REMARKS/ARGUMENTS**Objection to the Drawings**

Version With Markings to Show Changes Made

FIG. 2

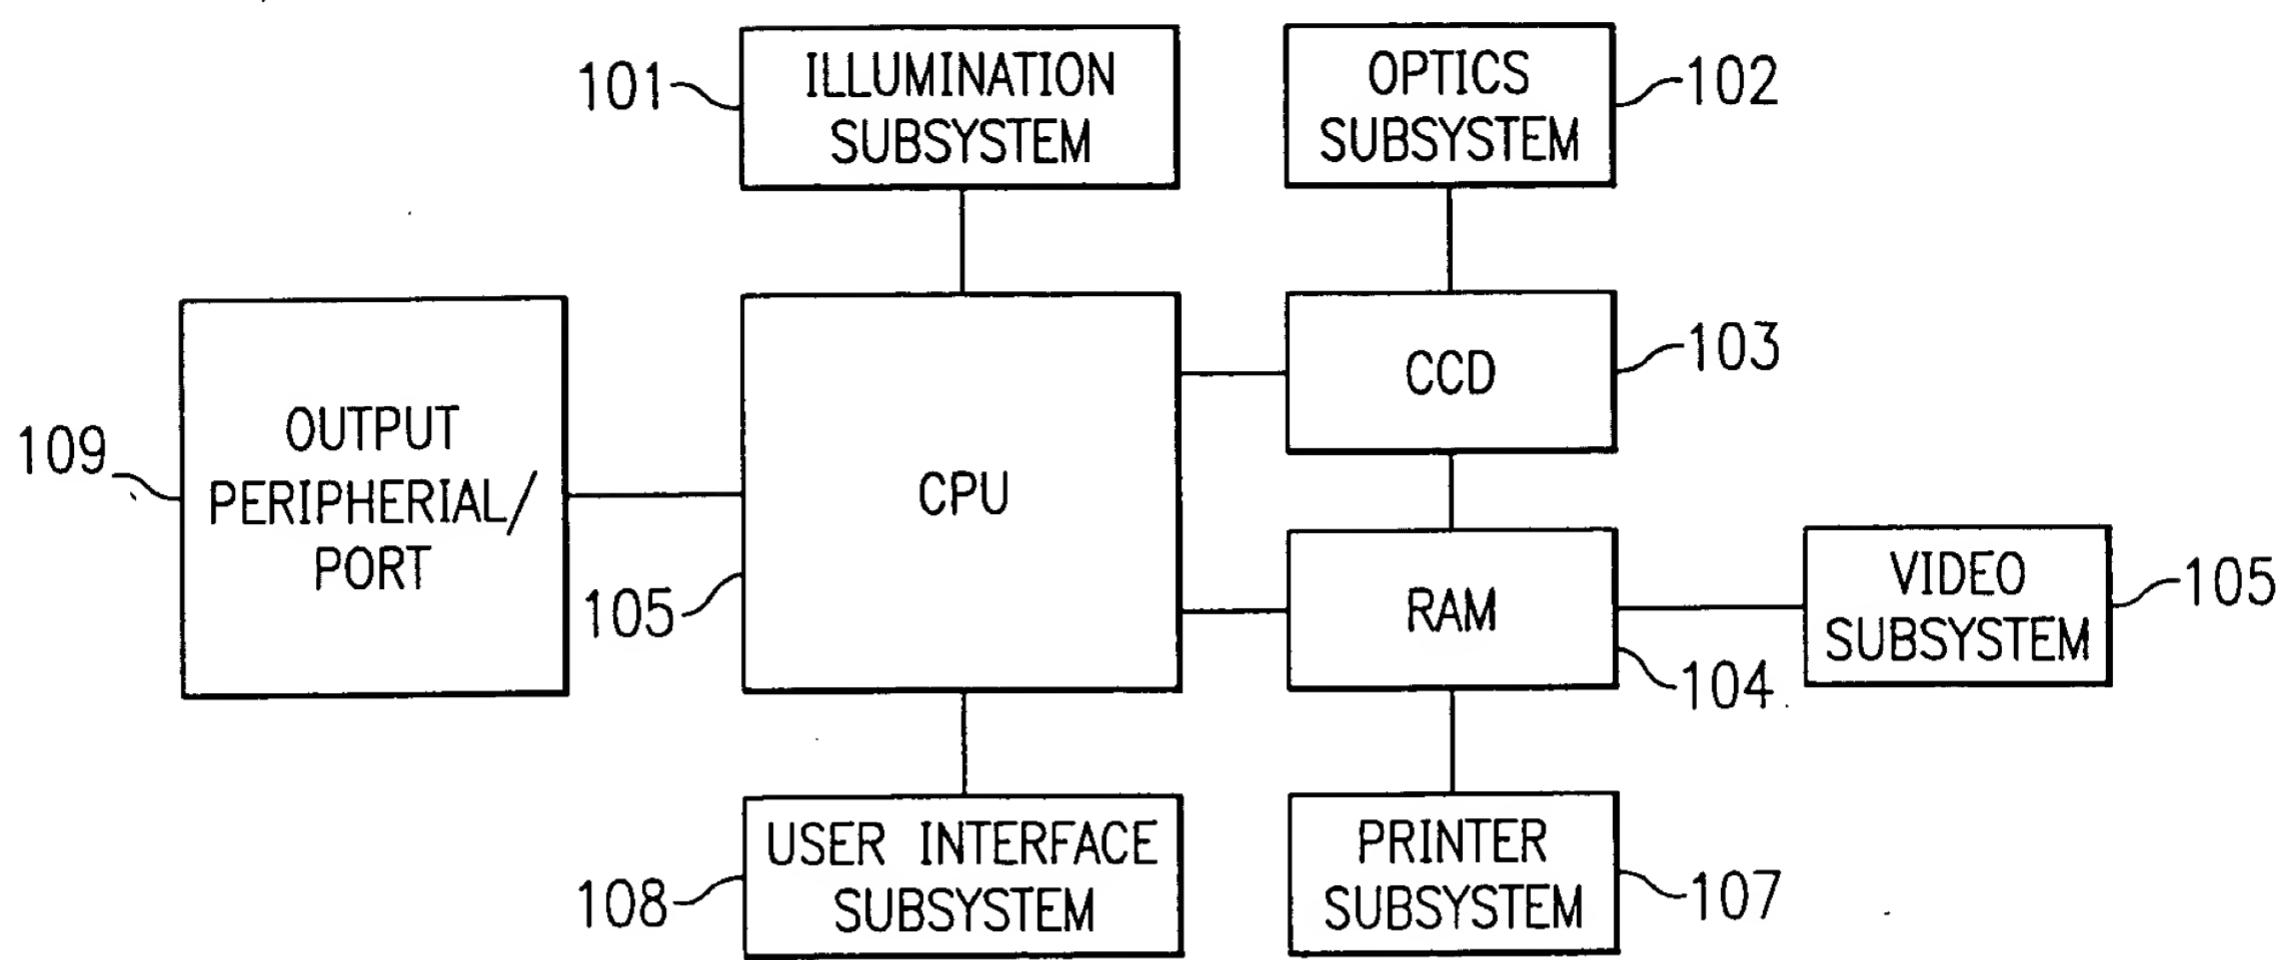
The drawings are objected to as failing to comply with 37 C.F.R. § 1.84(p)(5) including a reference numeral that is not mentioned in the description. Applicant submits a proposed drawing change to FIGURE 2 which shows the drawing change in red. The proposed drawing change deletes reference numeral “209” from FIGURE 2. Applicant will submit corrected formal drawings upon receipt of a notice of allowance. Accordingly, Applicant respectfully requests the Examiner to withdraw the objection to the drawings.
